October 12, 2016

MODENA STREET (HARRISON TO SPRING) SIDEWALK

Addendum #1

SHEET X-2

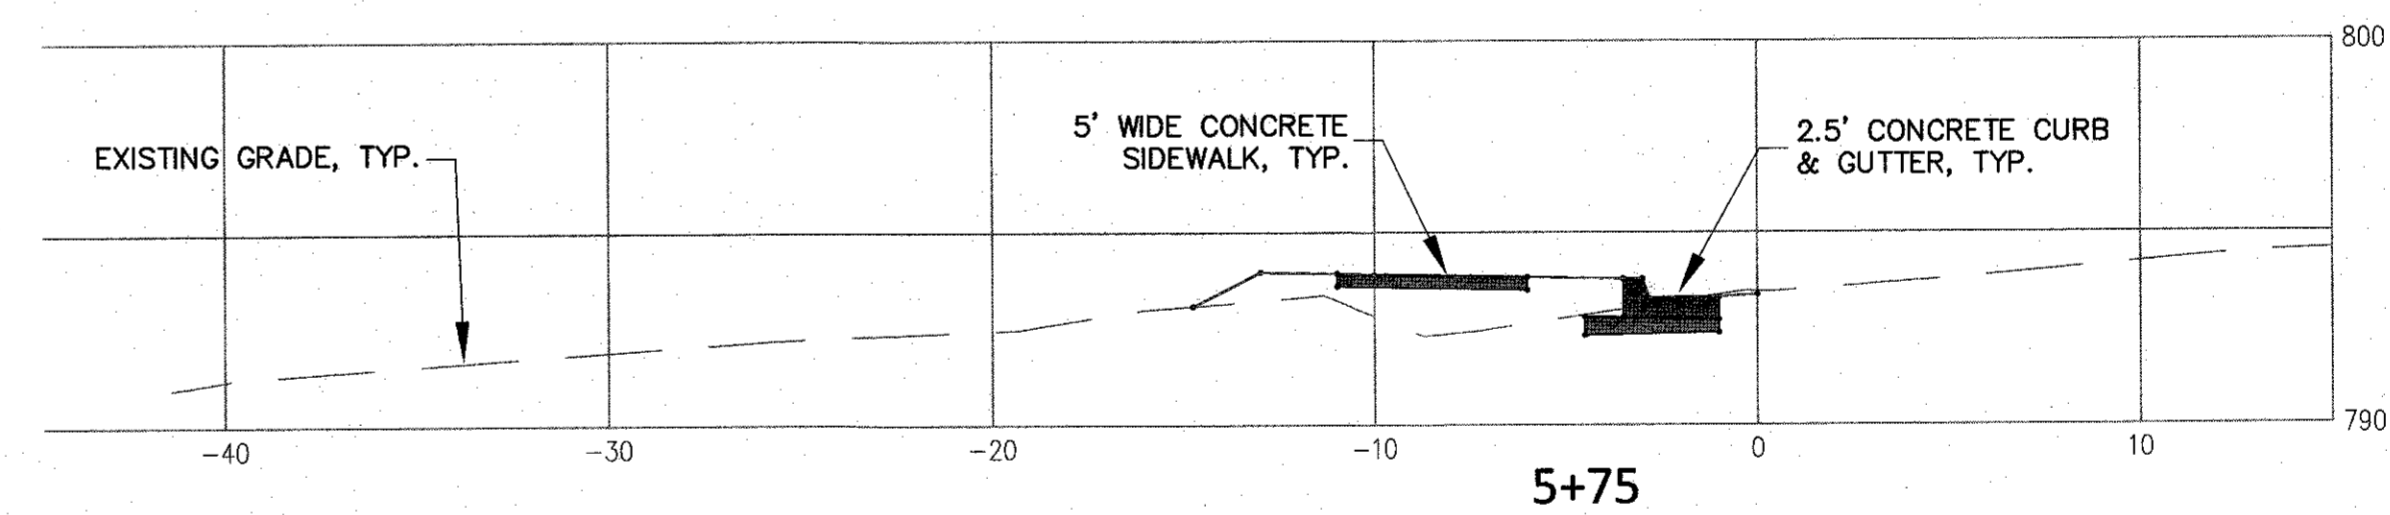
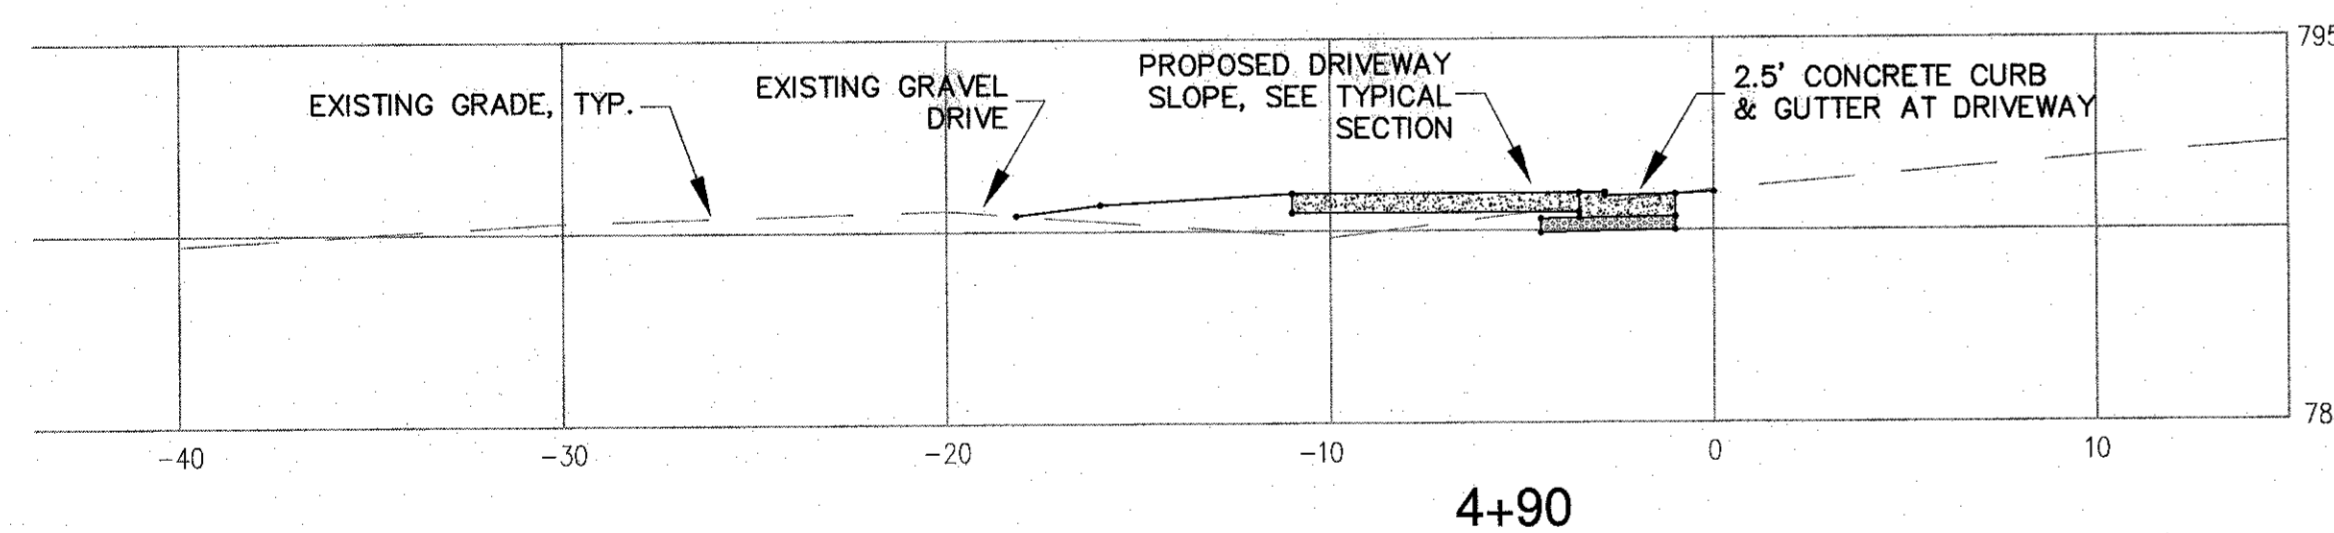
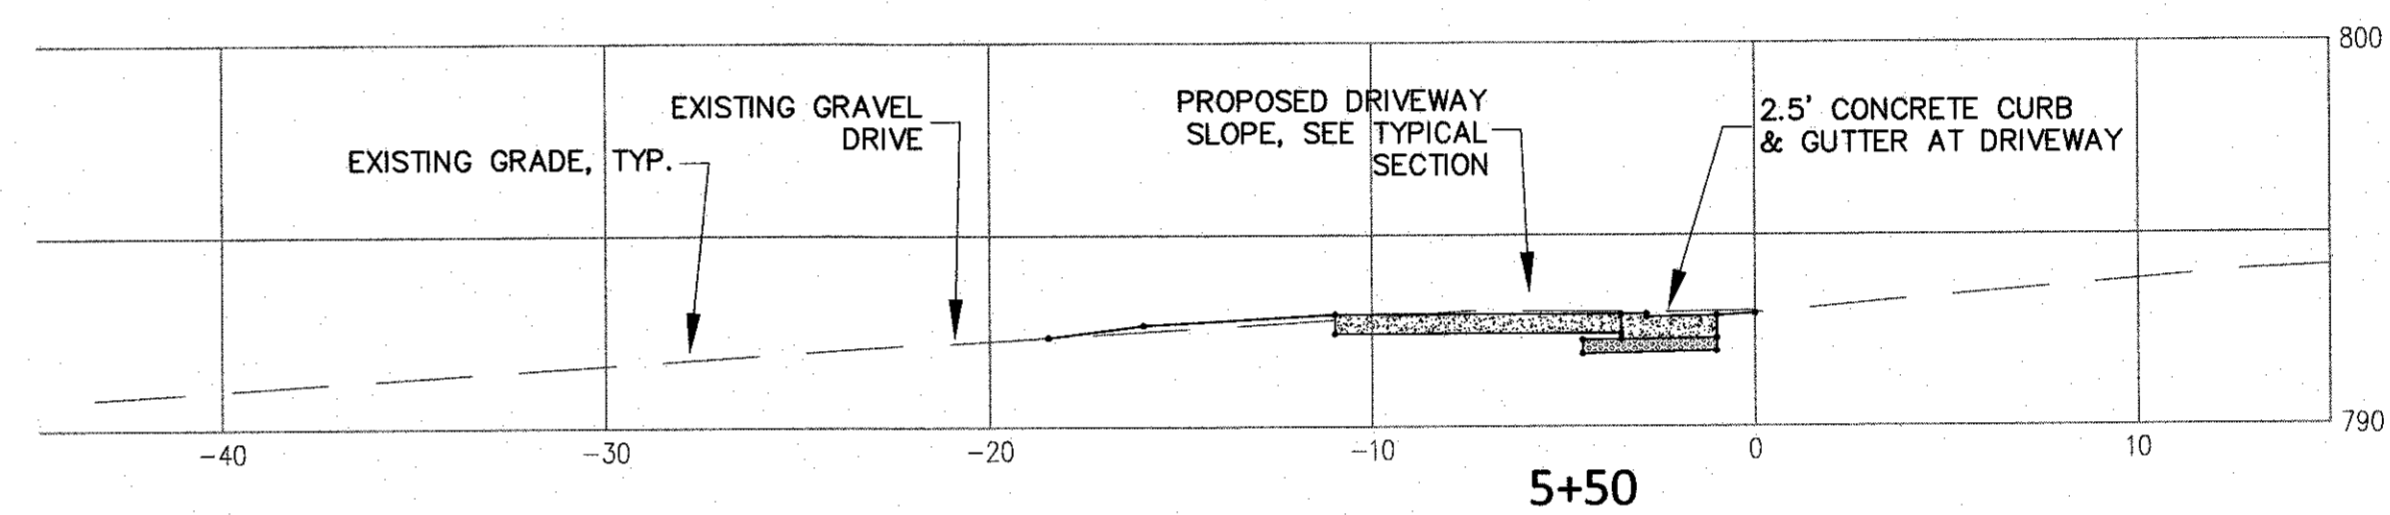
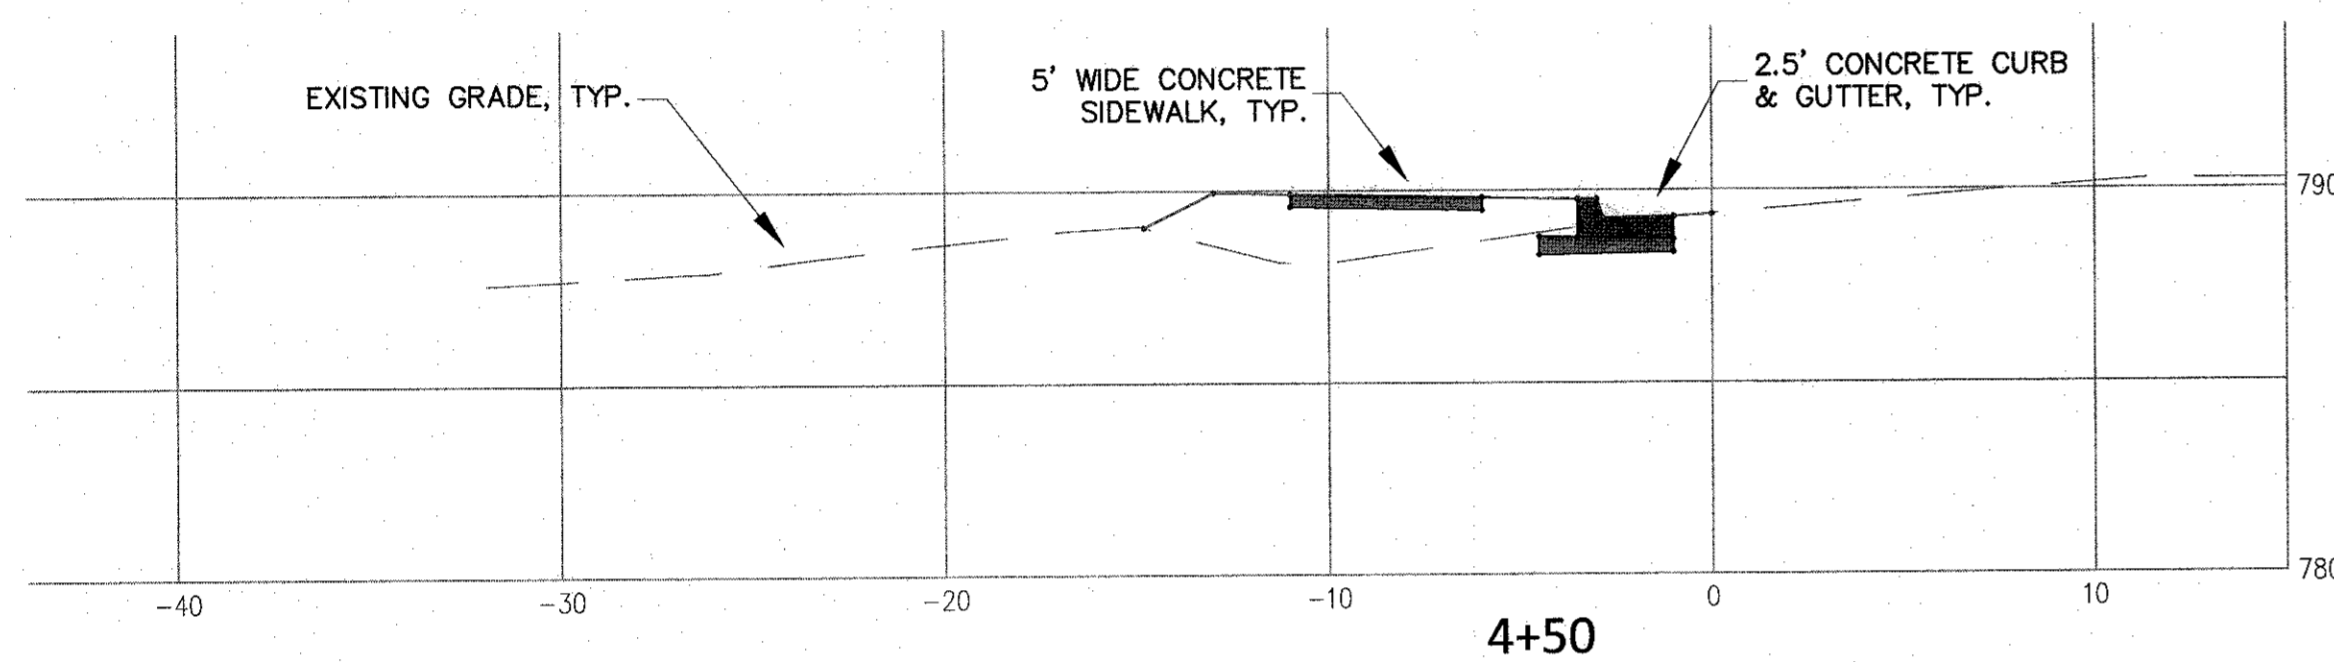
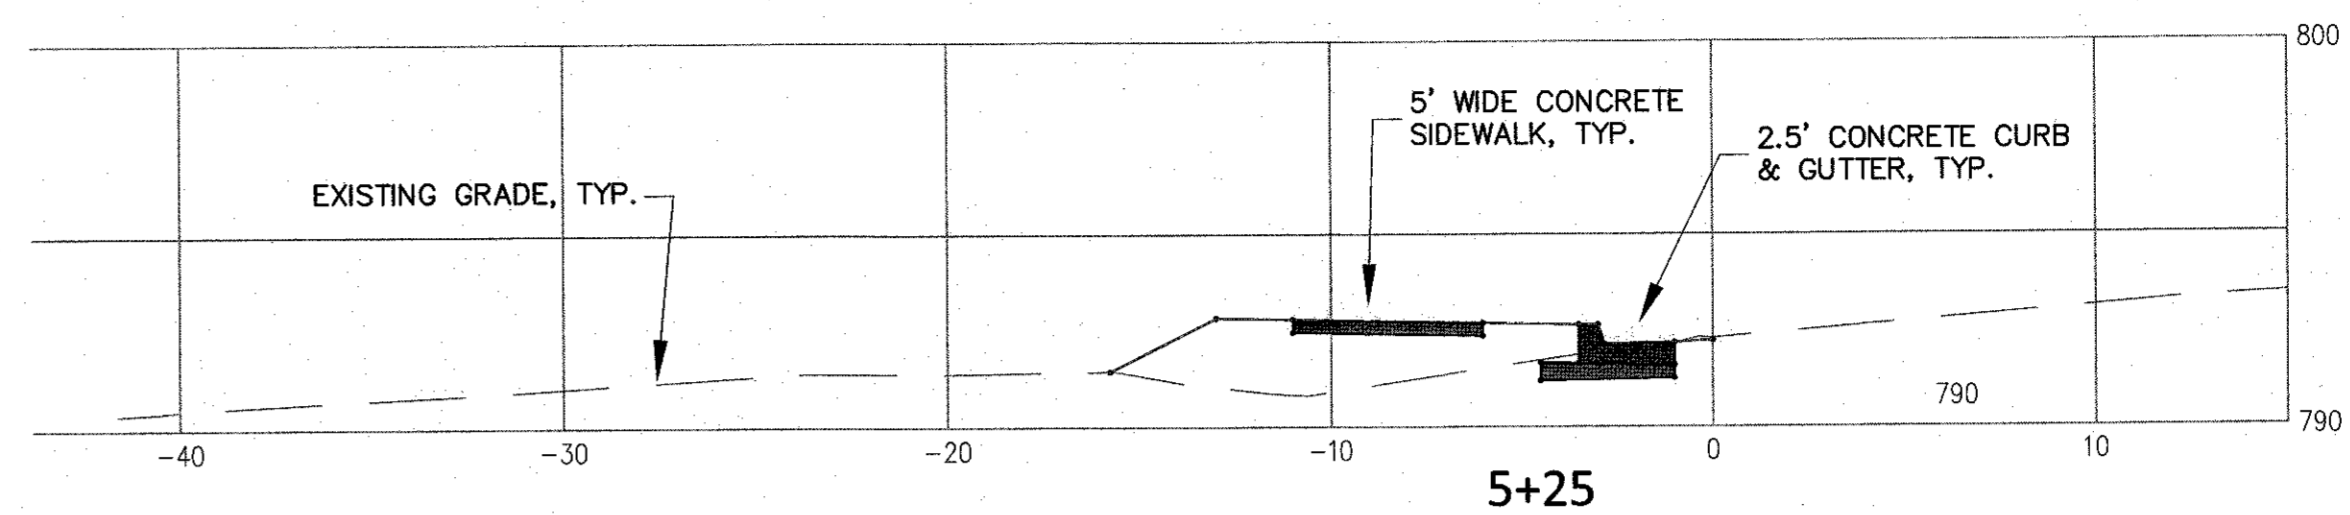
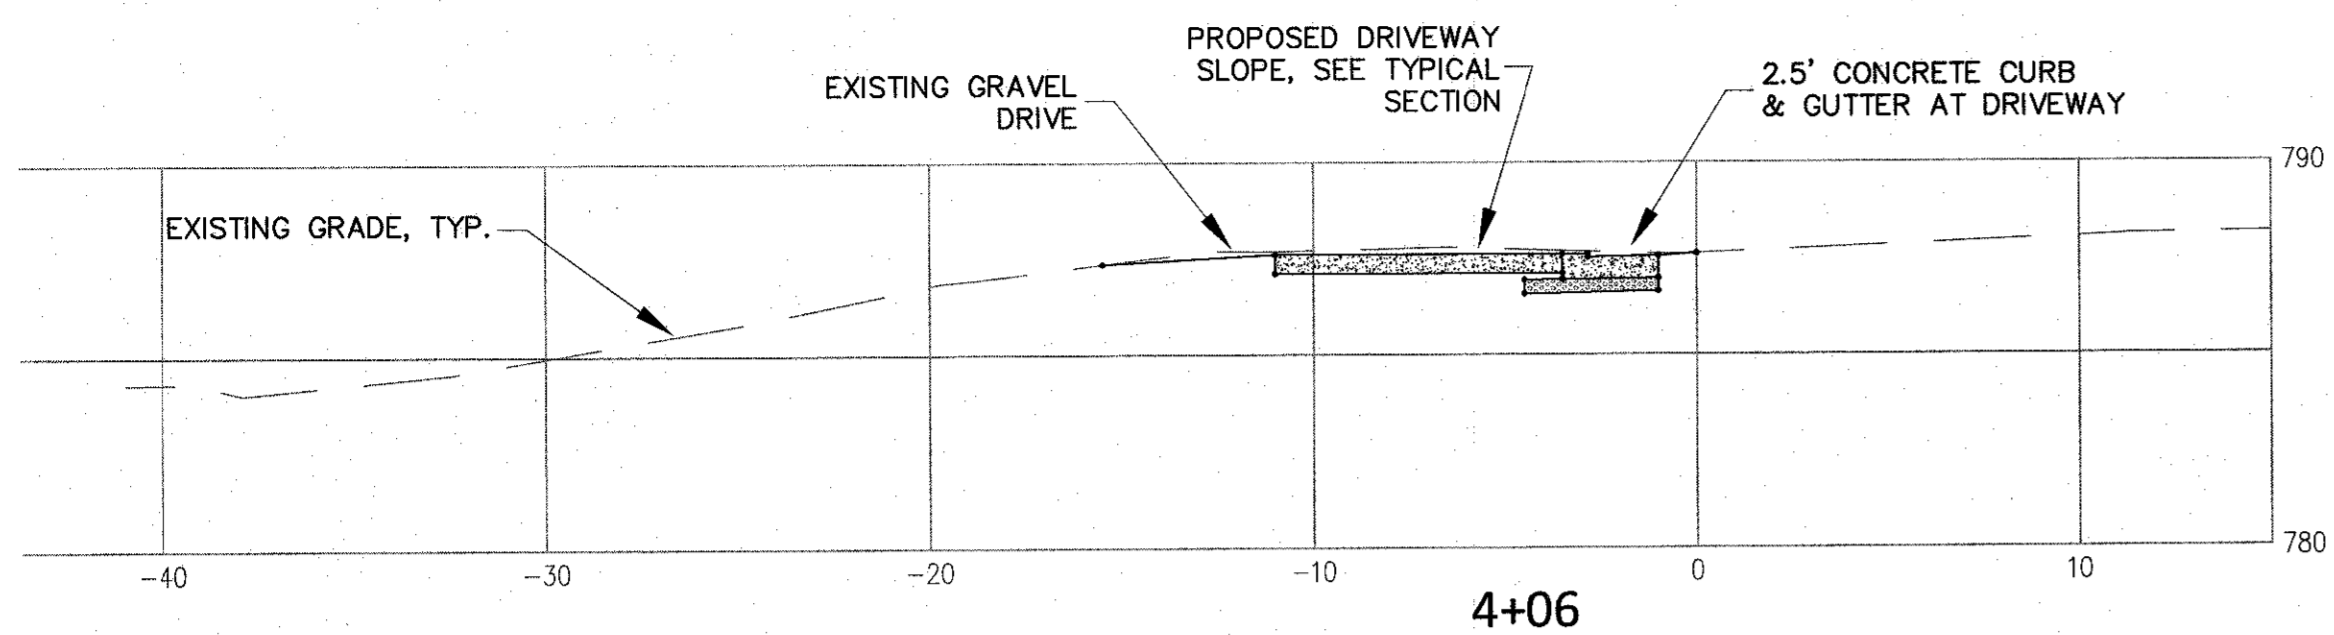
- Additional cross sections for proposed sidewalk from Sta. 0+00 to 9+00 and 13+50 to 16+09. (X-1 thru X-5) are attached to this Addendum. If you have already picked up your bid documents and plans, and would prefer a hard copy of the revised sheets, please contact caryr@cityofgastonia.com.
